February 8, 2010
NRC3-10-0003

Subject: Detroit Edison Company Response to NRC Request for Additional Information Letter No. 21

Response to RAI Letter No. 21
(eRAI Tracking No. 4120)

Figure 2.3-202

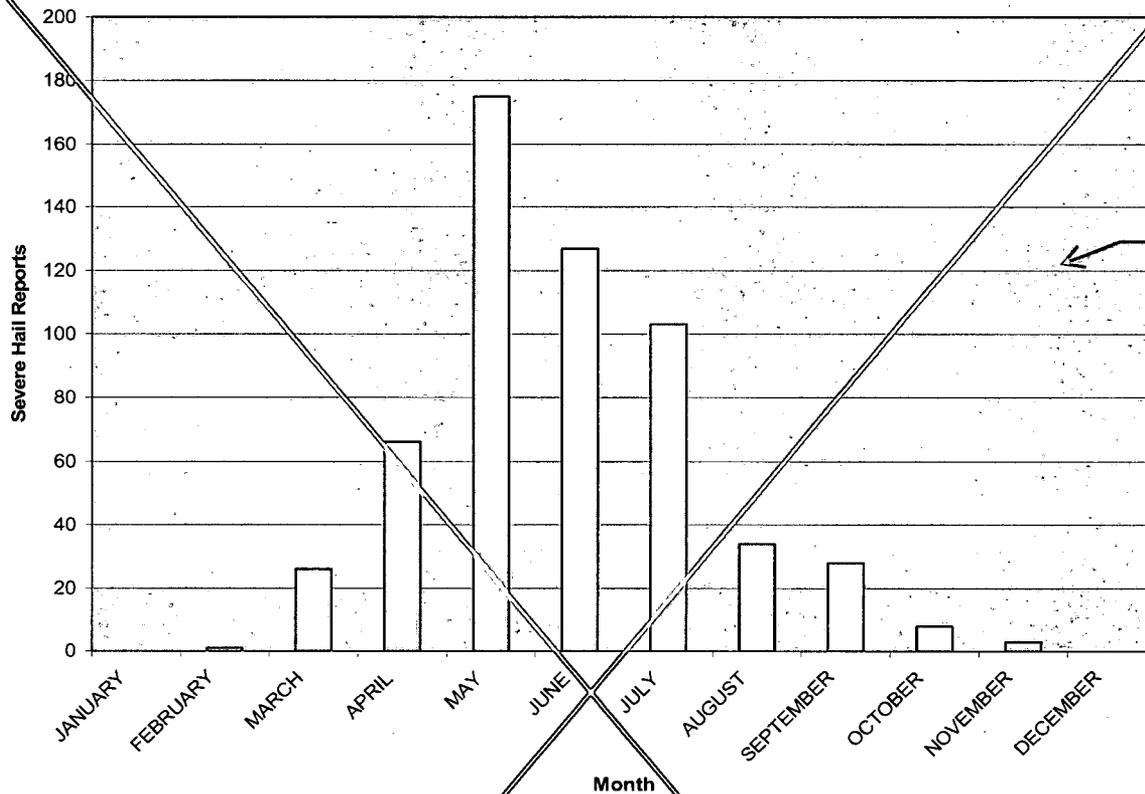
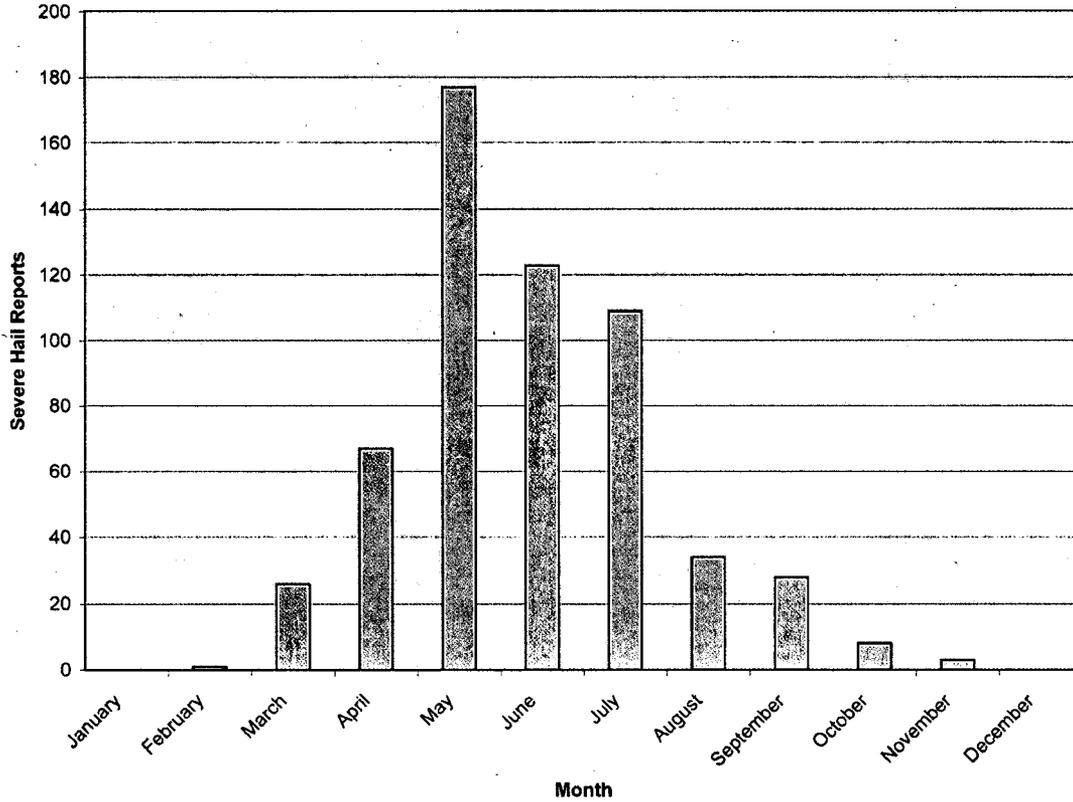
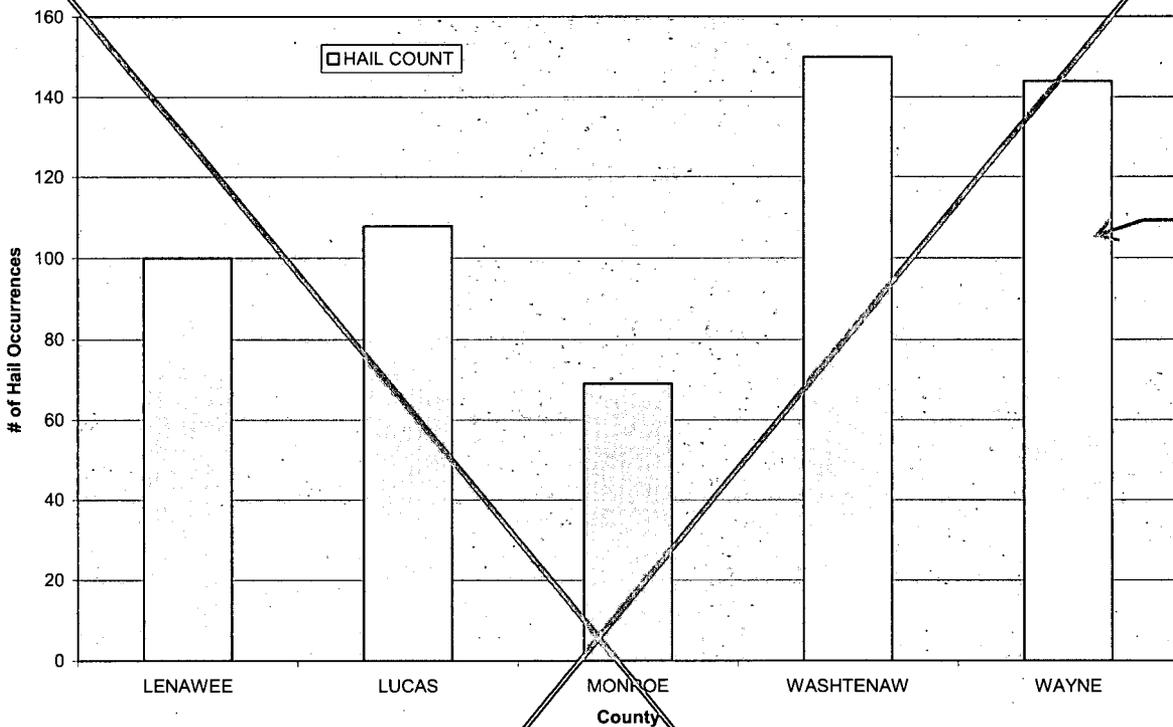
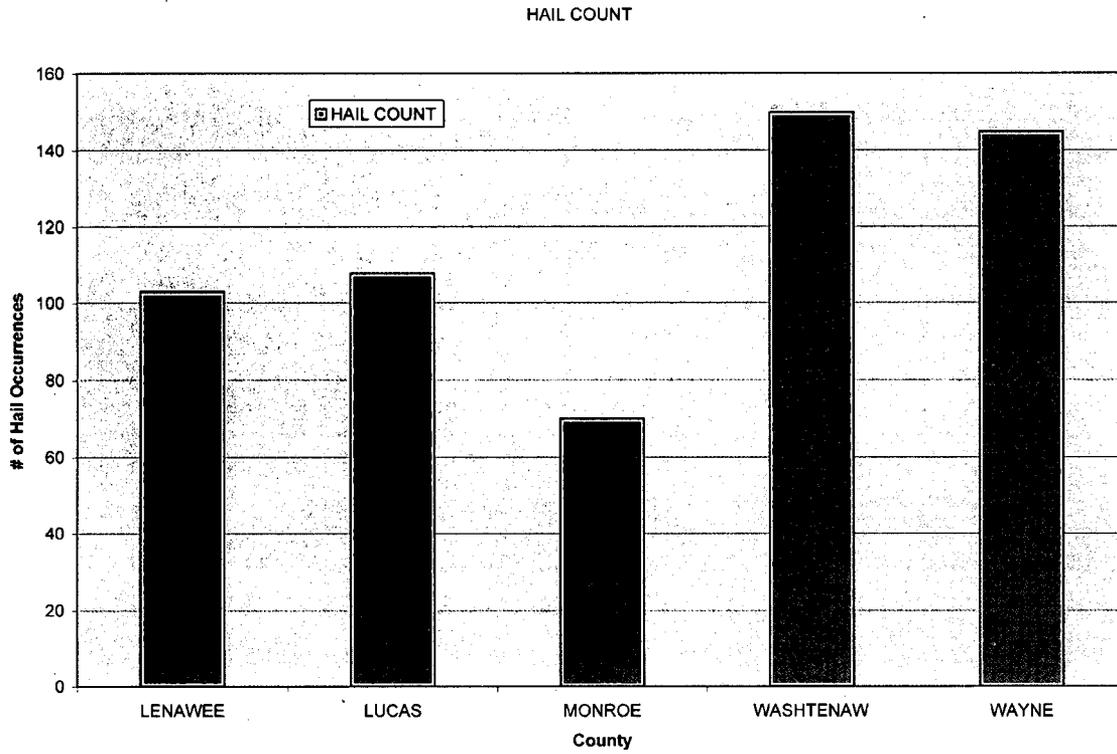
Confirm the number of hail events which FSAR Subsection 2.3.1.3.1.4 reports occurred in the five county area between January 1, 1955, and December 31, 2007, and revise the FSAR as necessary.

The following markup represents how Detroit Edison intends to reflect this RAI response in the next submittal of the Fermi 3 COLA Revision 2. However, the same COLA content may be impacted by revisions to the ESBWR DCD, responses to other COLA RAIs, other COLA changes, plant design changes, editorial or typographical corrections, etc. As a result, the final COLA content that appears in a future submittal may be different than presented here.

Figure 2.3-204

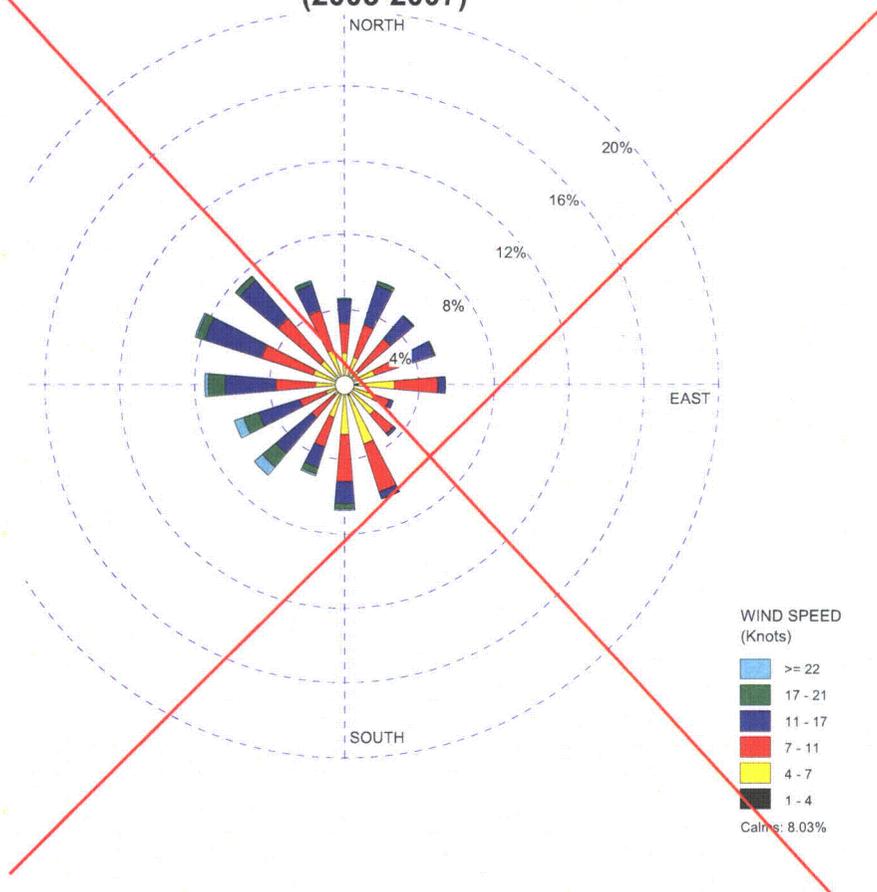
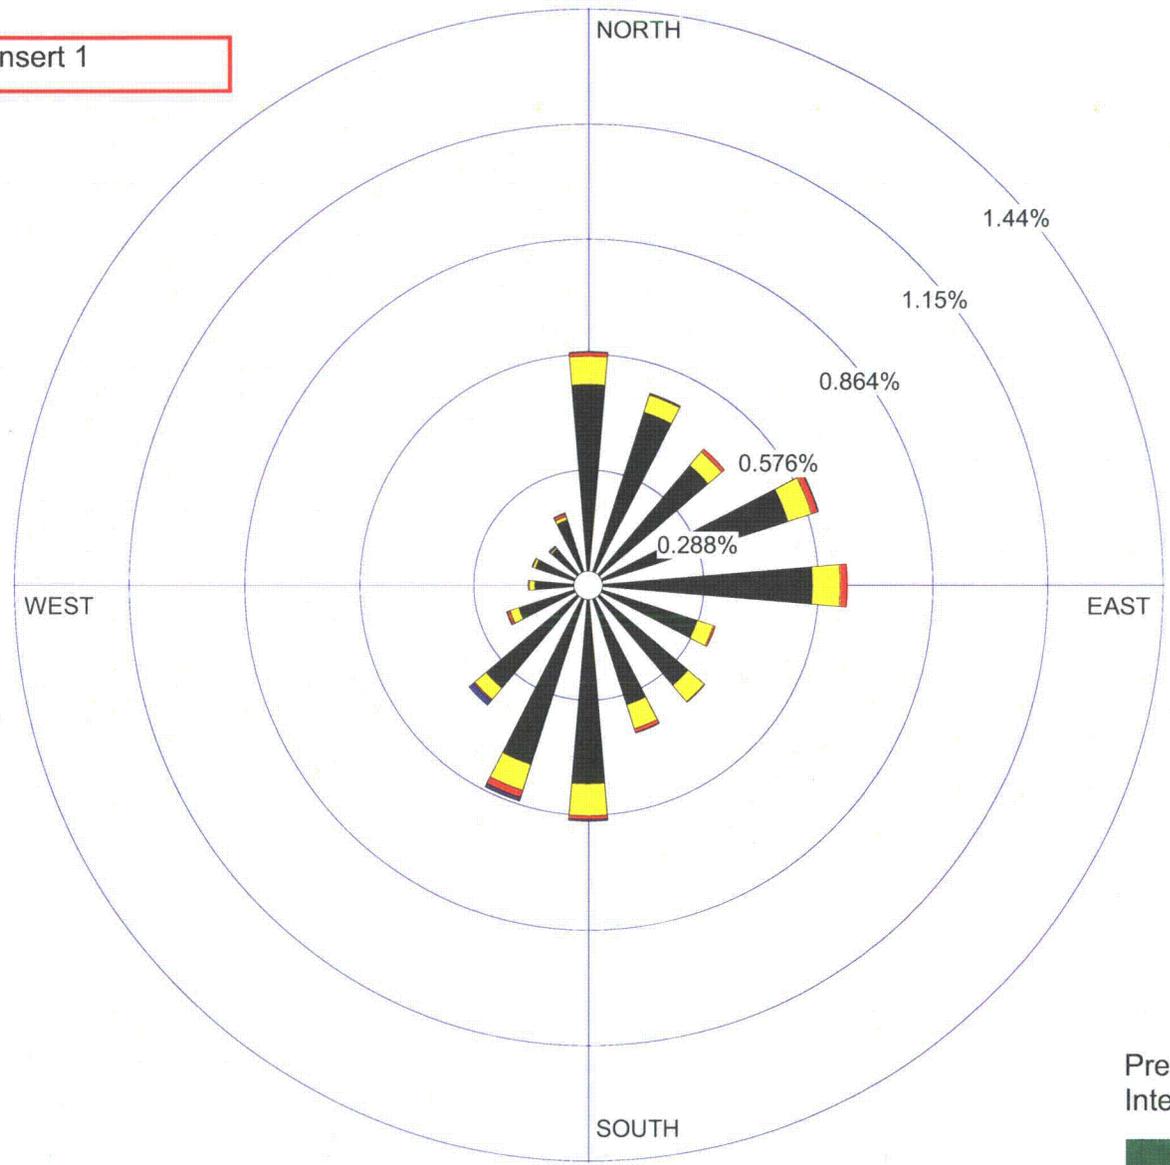
Did the contents of FSAR Figure 2.3-204 change from a precipitation rose in Revision 0 to a wind rose in Revision 1?

During the insertion of the text “[EF3 COL 2.0-8-A]” as part of Revision 1 to FSAR Figure 2.3-204, the precipitation rose graphic for Figure 2.3-204 was replaced, in error, with the wrong graphic, a wind rose.

The precipitation rose from FSAR, Revision 0 will be properly used for FSAR Figure 2.3-204 as shown in the proposed markup.

Figure 2, Meteorological Tower
Area - 2004

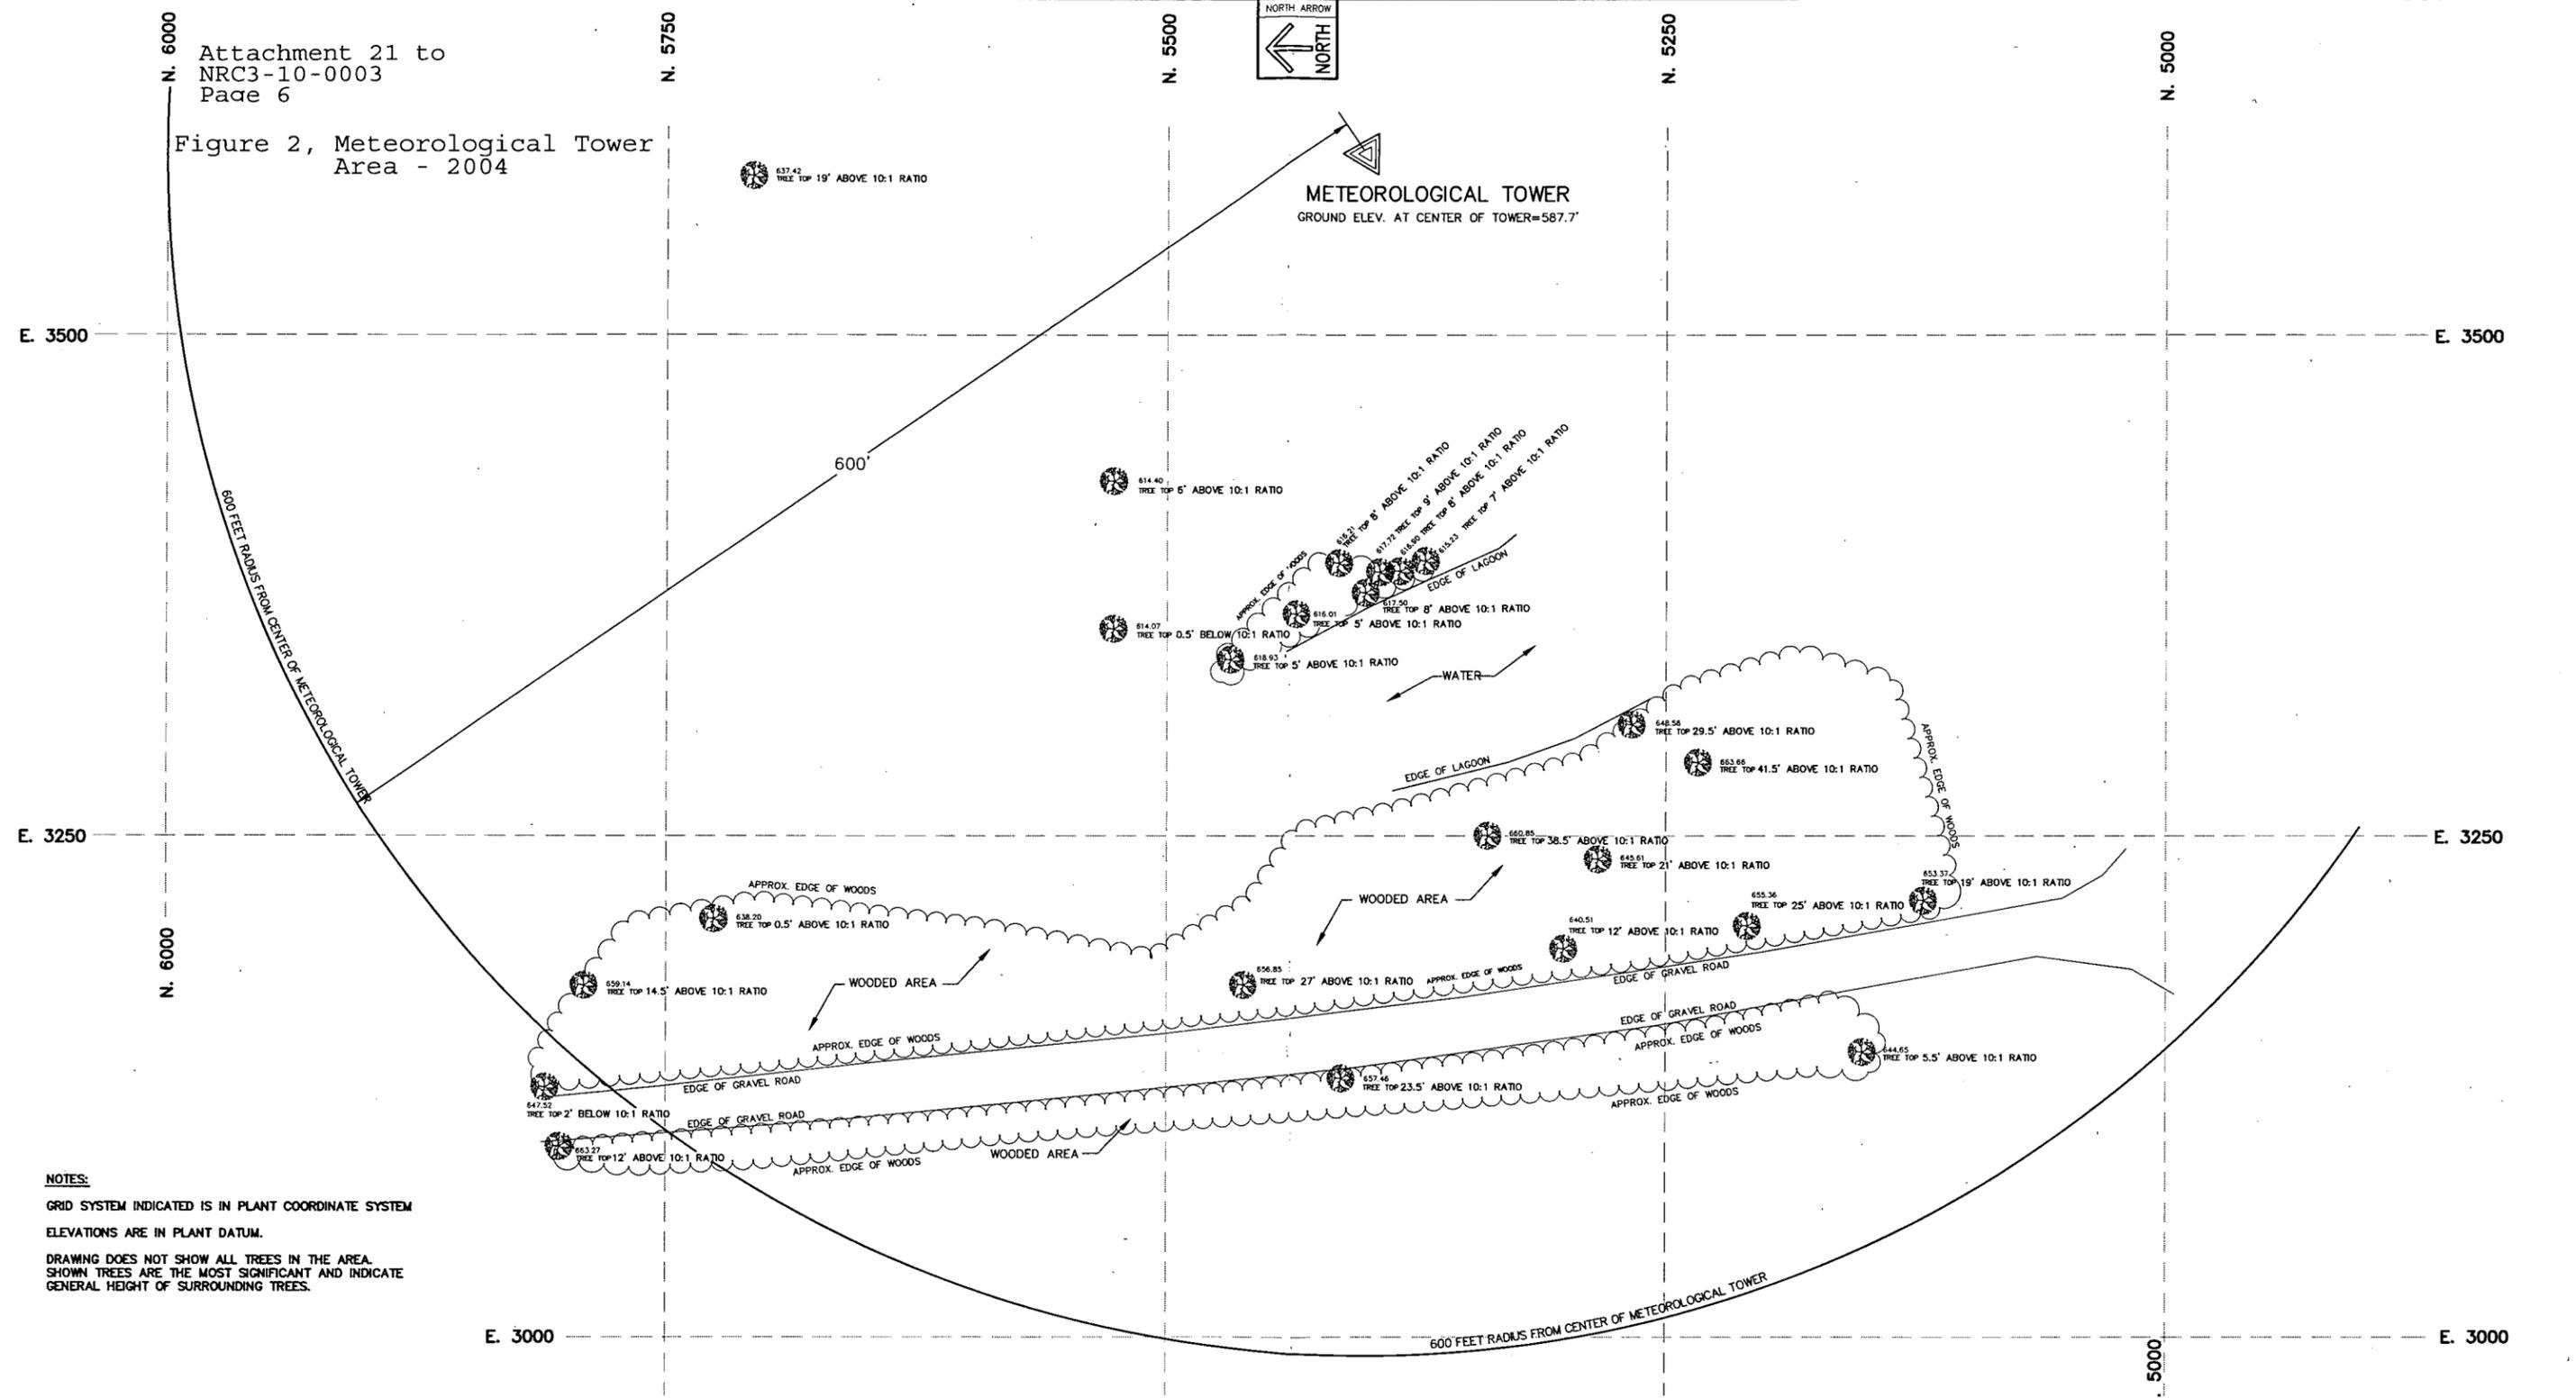
A current survey of the 60-meter meteorological tower area, provided as Figure 1 in Enclosure 1, shows the current separation between the wind instruments and the obstructions, in this case trees, is less than ten times the obstruction height recommended in Reg Guide 1.23 as annotated in FSAR Table 1.9-202 (sheet 3).

In 2004, Fermi 2 identified that obstructions, in this case tree(s), were present at a distance of less than ten times the height of the tree(s) against the recommendations of Reg Guide 1.23. As part of this evaluation, a survey of the 60-meter meteorological tower area was performed. The survey, provided as Figure 2 in Enclosure 1, confirmed that the separation between the wind instruments and the obstructions (in this case the trees) was less than ten times the obstruction height recommended in Reg Guide 1.23.

FSAR Section 2.3.3.1.1 is being revised to provide a discussion the trees to the west of the Fermi meteorological tower and an insert statement to FSAR Table 1.9-202 (Sheet 3 of 24) pointing to FSAR Subsection 2.3.3.1.1 for the justification for the exception of the obstruction distance guidance as required by Reg Guide 1.23 as shown in the proposed markup.

Figure 12, Fermi 2 UFSAR Figure 2.3-19

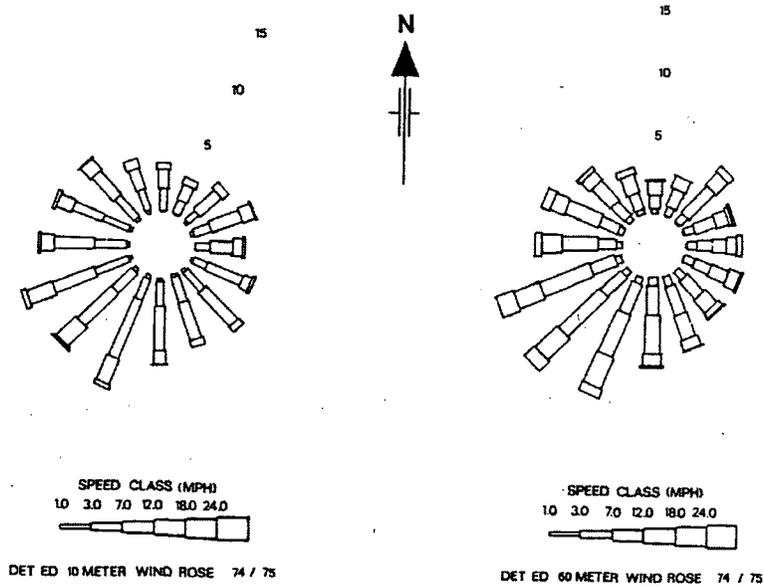
Using the wind roses and stability class information for the time period from June 1, 1974 through May 31, 1975 in the Fermi 2 UFSAR, provided as Figure 12 in Enclosure 1, Detroit Edison evaluated the impact of the trees, by comparing the 10-meter and 60-meter wind roses from the 1974/1975 time frame with 10-meter and 60-meter annual wind roses from 1985, 1994, 2003, 2004 and 2005, provided as Figures 3 through 11 in Enclosure 1 and concluded that there was no significant difference in wind direction and speed patterns between the time periods analyzed. Thus, the trees to the west and southwest of the meteorological tower had not altered the wind flow patterns measured at the 60-meter meteorological tower prior to 2004.
